To	Annarie Boer (EPA)	Contact No.	
Copy to	Anne Price, Greg Phyffer	Email	
From	Tristan Sleight	Project No.	12627587
Project Name	North Kiaka Project		
Subject	Additional information to support the North Kiaka s40 (2)(a) Environmental Assessment 2346

1.2 Purpose of this Memorandum

The purpose of this document is to provide responses to the Requests for Further Information on Flora and Vegetation and Fauna to supplement the s40(2)(a) ERD. Comments were received from EPA Services, DCCEEW and DBCA.

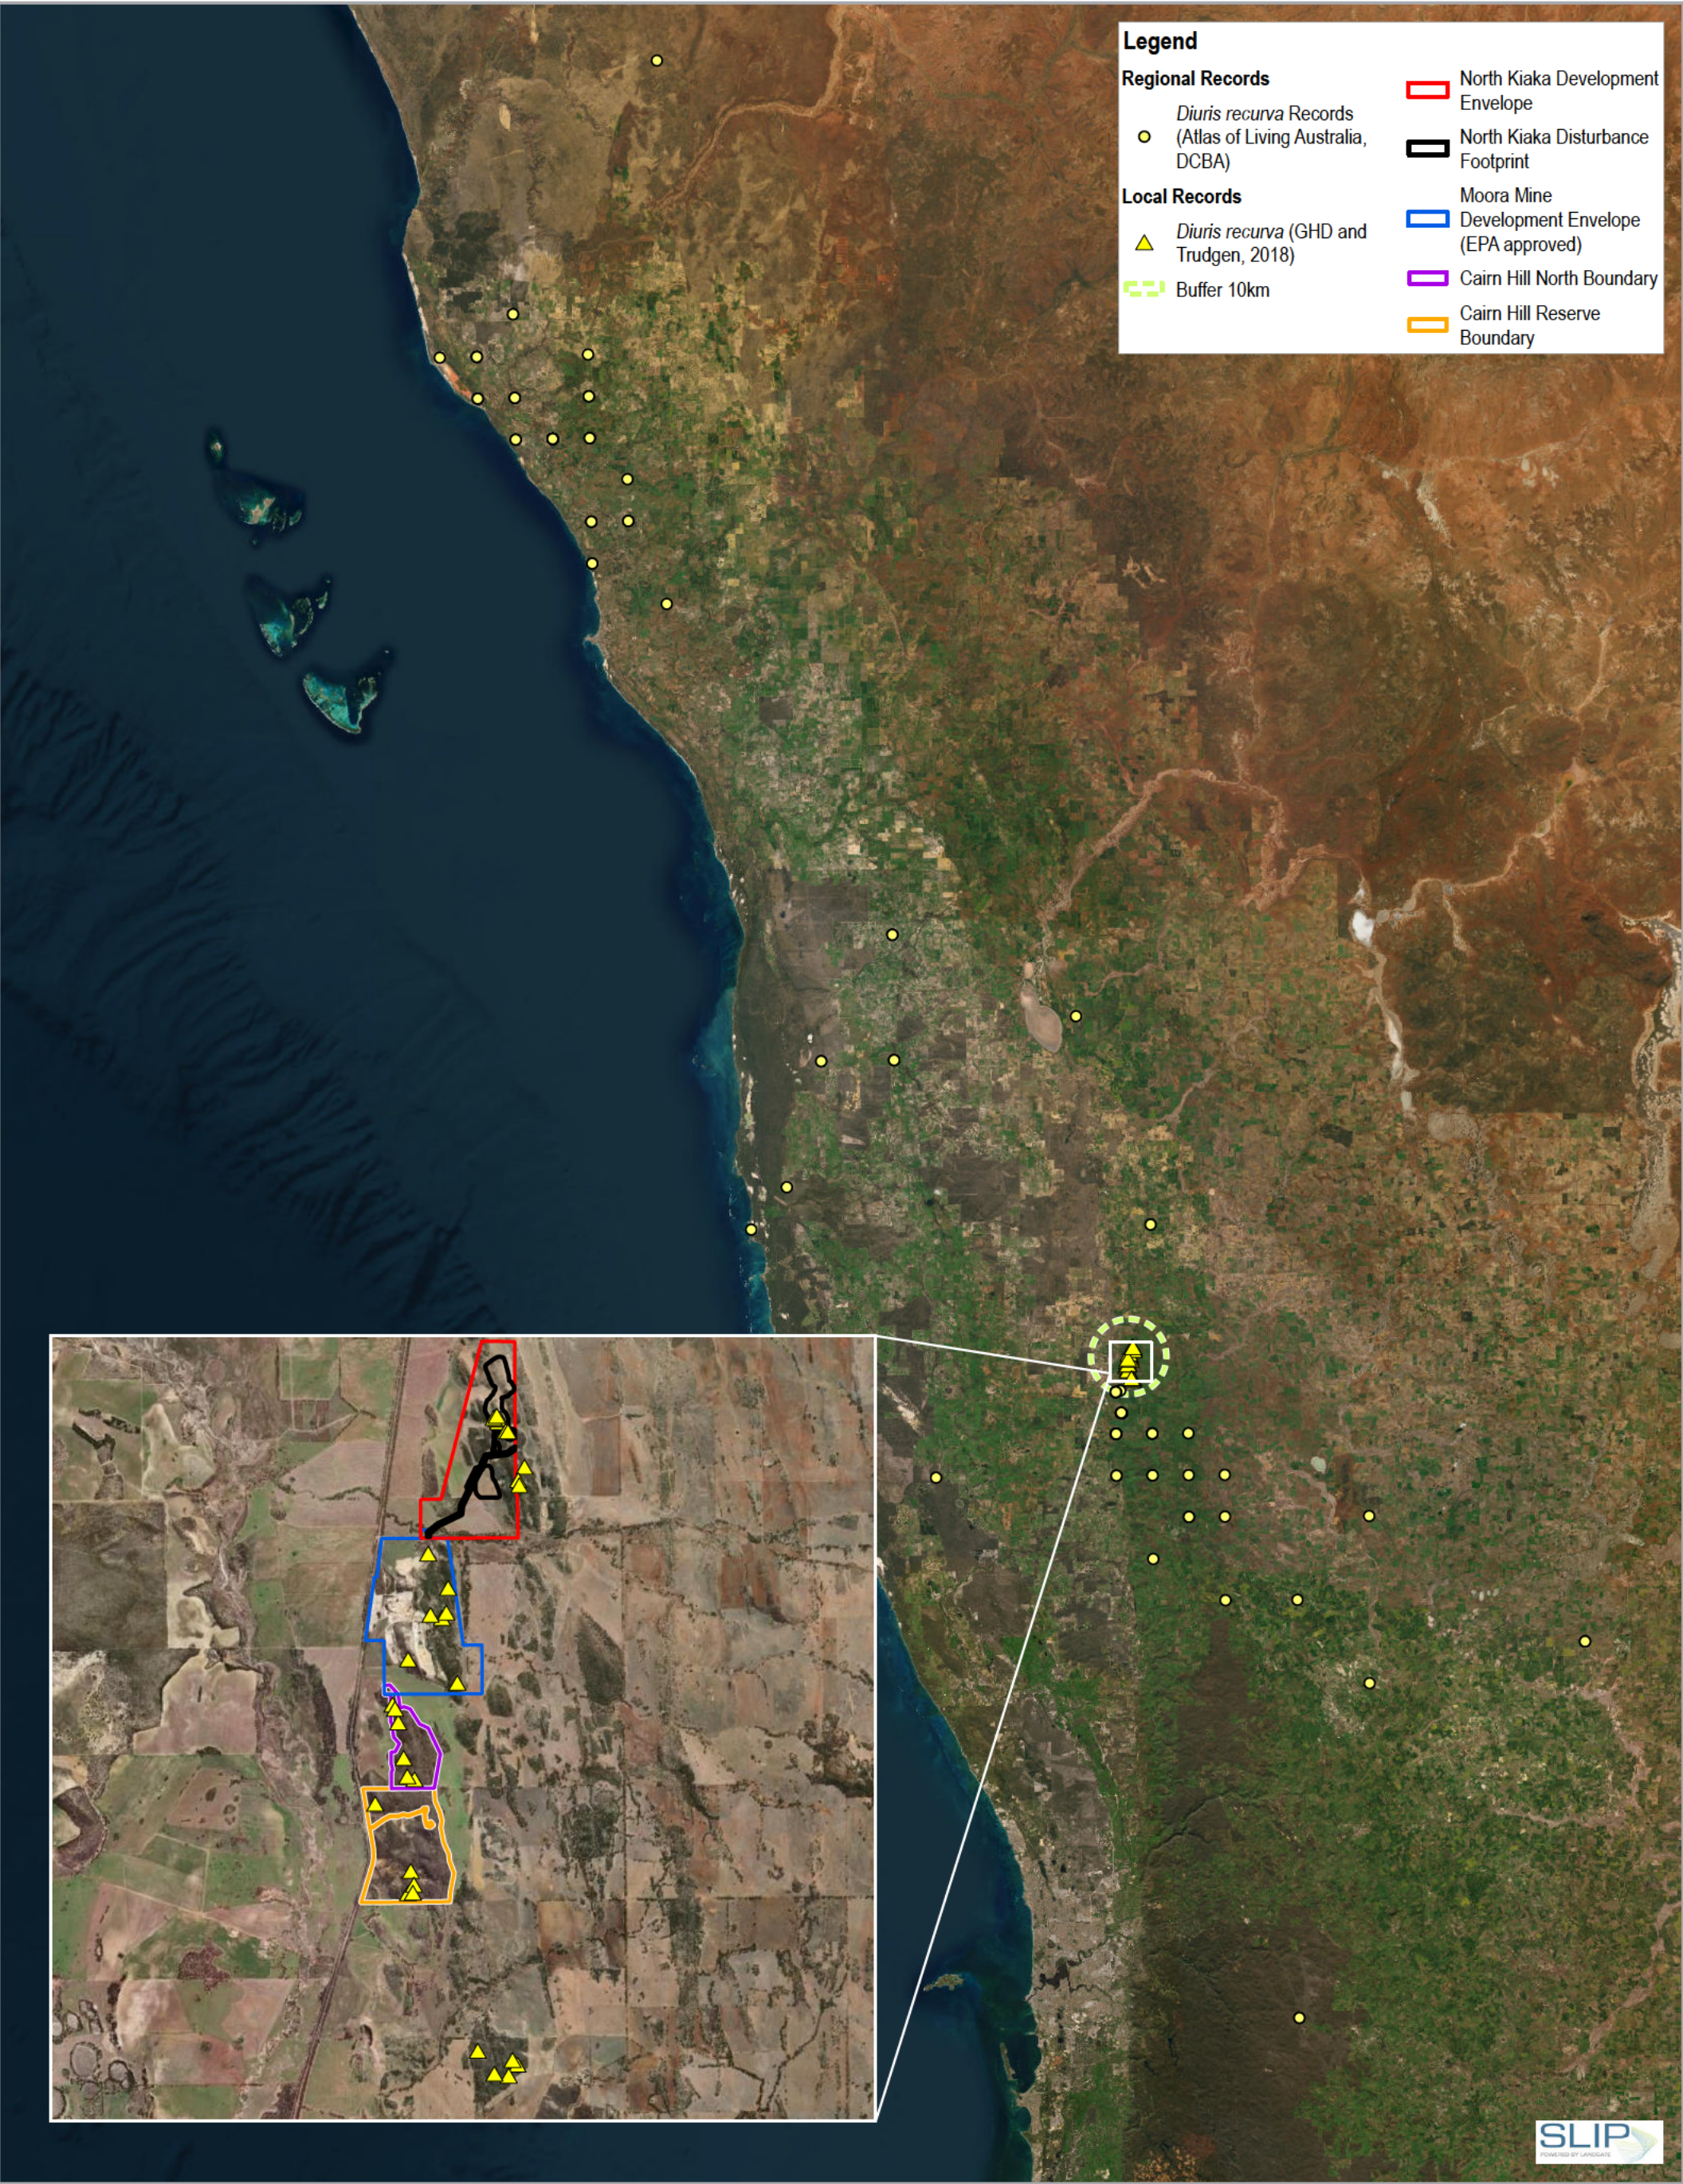
3. Flora and vegetation - the predicted direct impact to *Diuris recurva* (Trudgen 2018 records) remains high and requires additional analysis. Although the predicted impacts to *Stylidium sp. Moora* (P2) are lower, expert comment would add to the rigour of the assessment and level of conditioning.

3a Please provide a short expert opinion (memo or letter) on the significance of the potential local and regional impacts of the proposal on *Diuris recurva* and the conservation of the species (e.g. a possibility of an increase in conservation listing), uncertainties and actions that may reduce uncertainties

3b) Include, if available, the following detail on information already provided for *Diuris recurva*:

- i. total number of individuals within the 11 populations that occur within the offset sites and within which of the two offsets sites they are located
- ii. source of the information for 104 total occurrences within the known range of 470 km north to south

Locally, this species has been recorded within the conservation estate (Cairn Hill Reserve and Cairn Hill North) and the distribution of the population is well known regionally, as shown in Figure 1 (WA Herbarium dataset). There does however exist uncertainty around total population numbers at both local and regional scales. To decrease the uncertainty around this species populations, surveys during optimal flowering periods are proposed to be undertaken to provide an updated abundance of the local population. This may also inform longer term monitoring programs to measure changes to local populations of this species. Given the large regional extent over which this species occurs, total population numbers across the extent of occurrence will be difficult to define and will not inform any assessment of significance of regional impacts.

The known records of *Diuris recurva* occur across a range of 470 km north to south (ALA 2025, WA Herbarium 2024) (refer Figure 1 and Table 1). The Revised Proposal lies within the central portion of the regional known extent of the species. The Revised Proposal will directly impact 33% of the records within the known extent of the species, which includes the North Kiaka Development Envelope (DE) and North Kiaka Disturbance Footprint (DF), Moora Mine Disturbance Footprint (DF) and Cairn Hill and North Cairn Hill offset areas (10km buffer showing local¹ occurrences). Within the 105 (updated from the 104 occurrences) regional records (500km range), sourced from ALA or the WA Herbarium (DBCA dataset), records do not include abundance data. The abundance data was not collected at the time of surveys, or the records are vague to avoid disturbance of remaining populations.

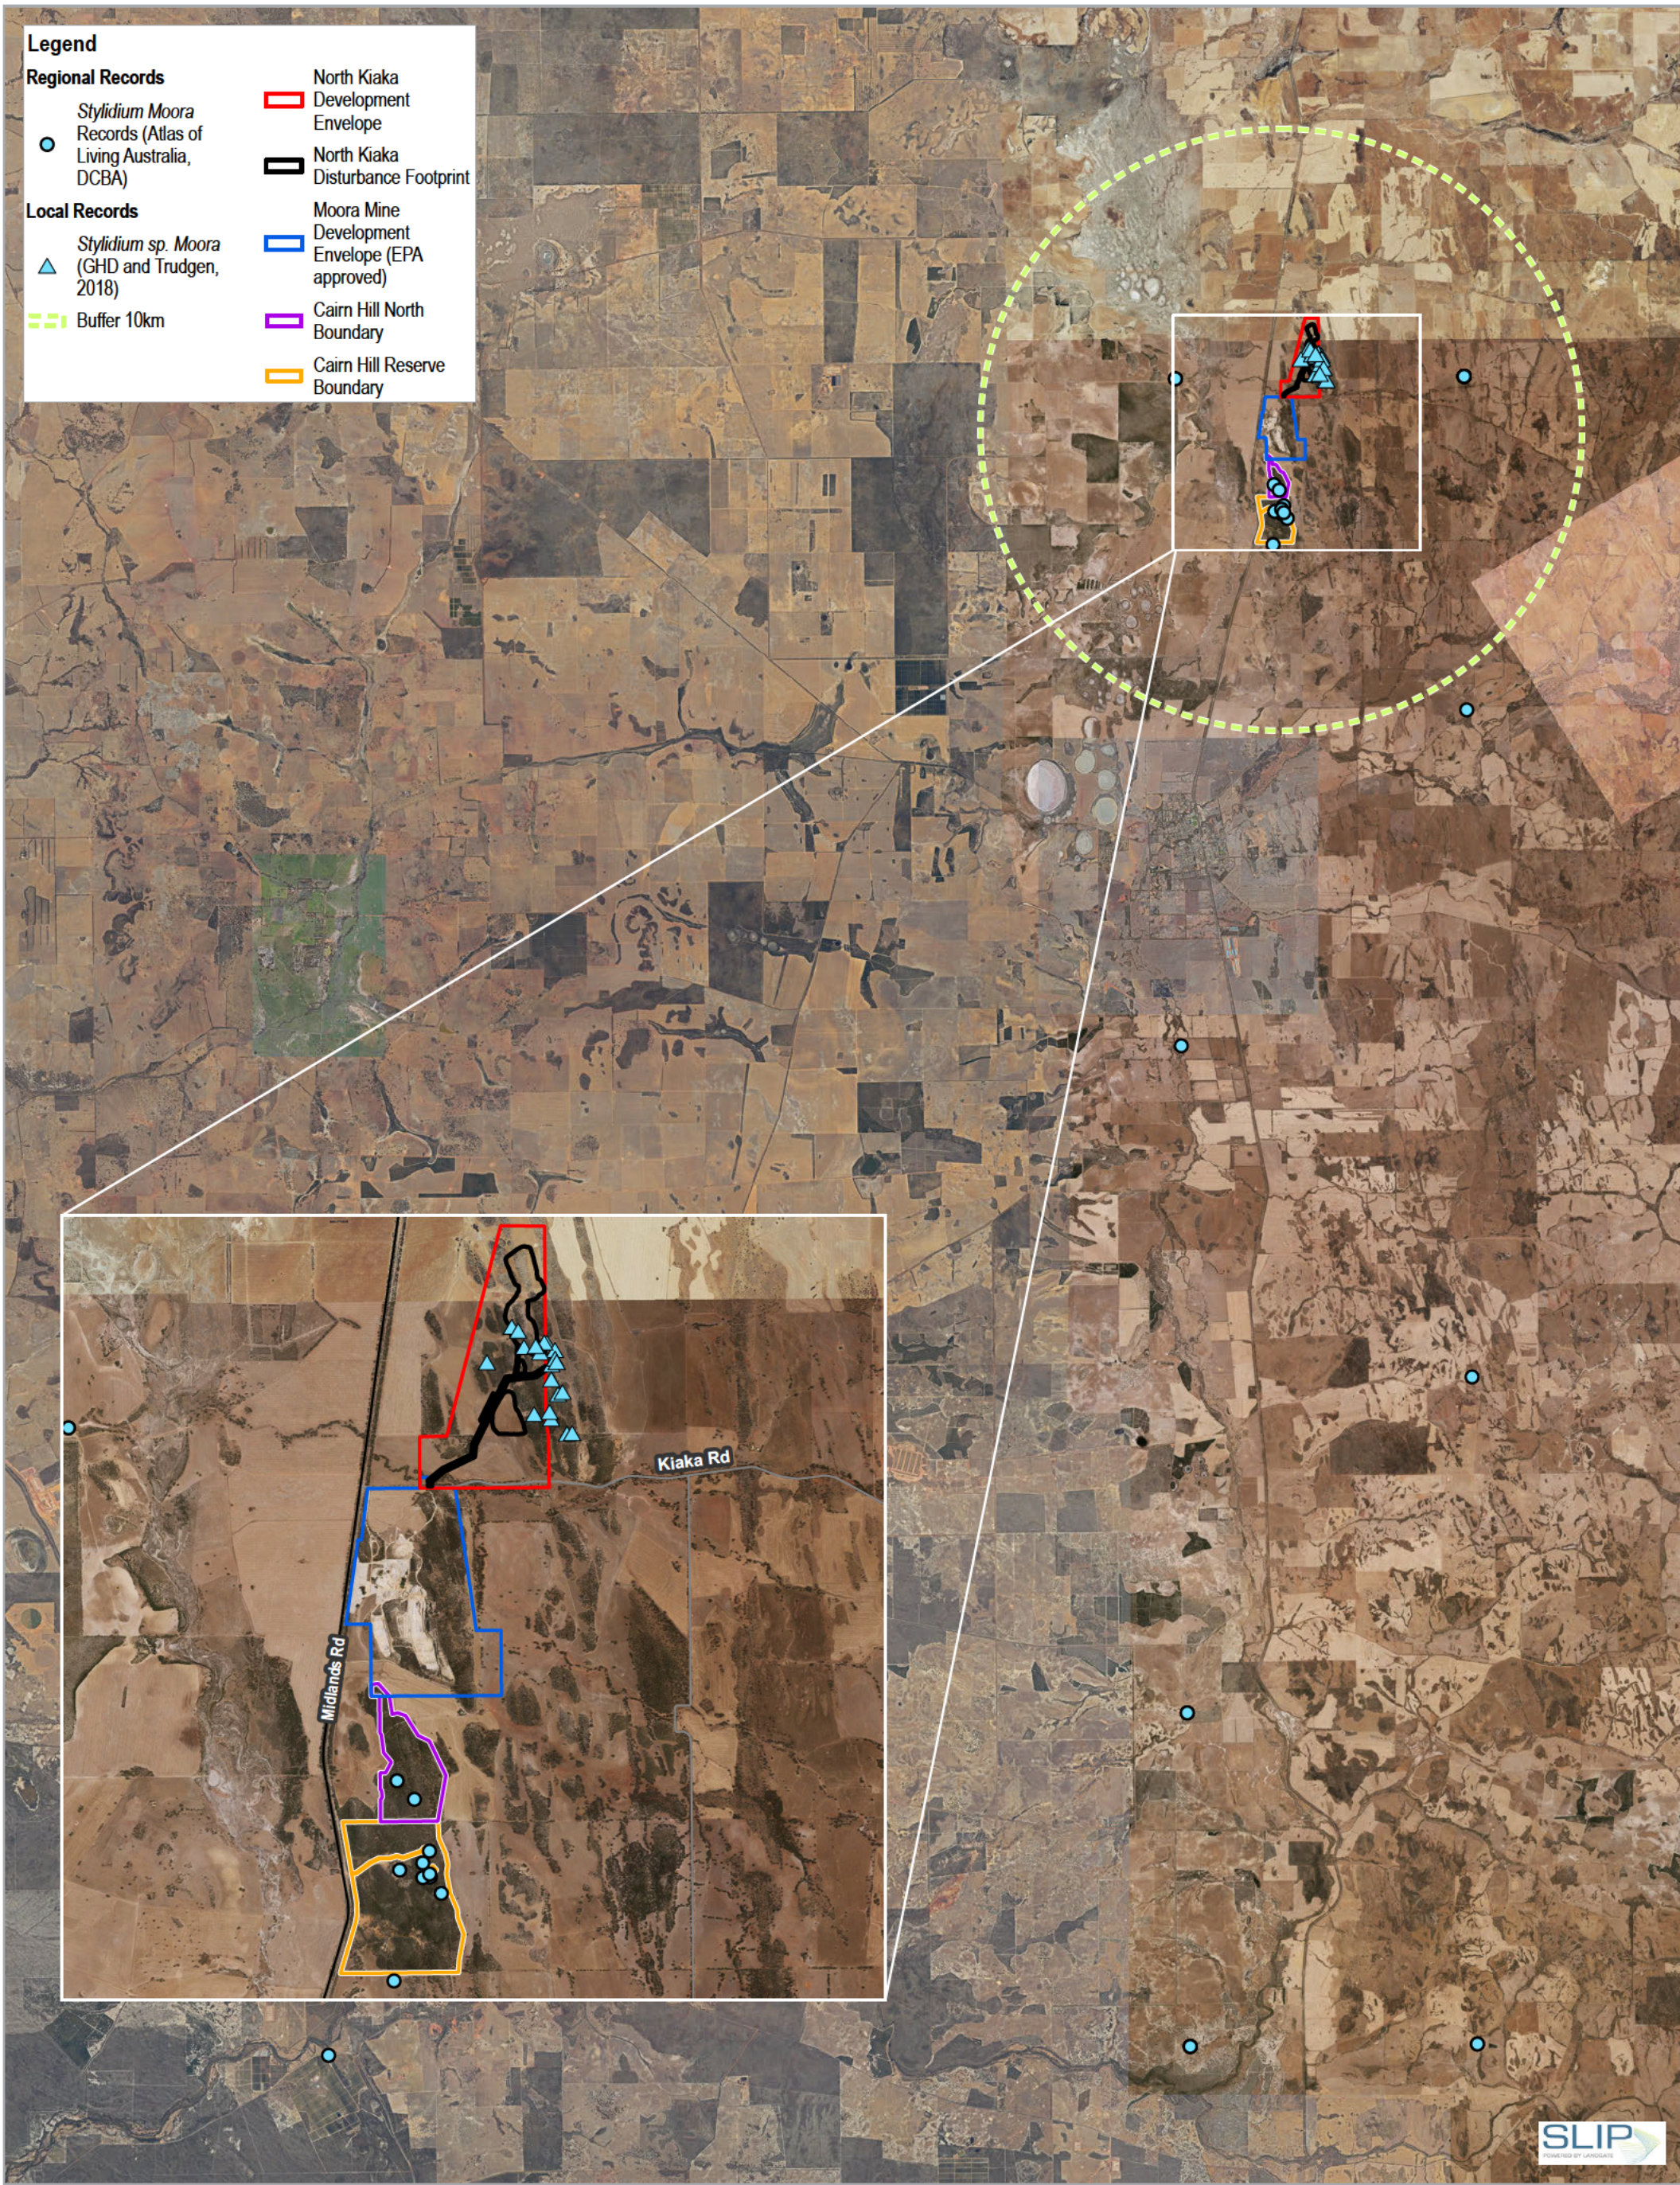
(3c) Provide expert opinion/comment on the significance of the potential local and regional impacts of the proposal on *Stylidium sp. Moora* (P2) and the conservation of this species and uncertainties.

The previously known records of *Stylidium sp. Moora* occur across a range of 57 km north to south (ALA 2025, WA Herbarium 2024) (refer Figure 2 and Table 3). The Revised Proposal represents the northern extent of the known records of this species. The Revised Proposal will directly impact 4.5% of the occurrences within the known extent of the species, which includes the North Kiaka Development Envelope (DE) and North Kiaka Disturbance Footprint (DF), Moora Mine Disturbance Footprint (DF) and Cairn Hill and North Cairn Hill offset areas.

Locally, this species has been recorded within the conservation estate (Cairn Hill Reserve and Cairn Hill North) and the distribution of the population is well known regionally, as shown in Figure 2 (WA Herbarium dataset⁴).
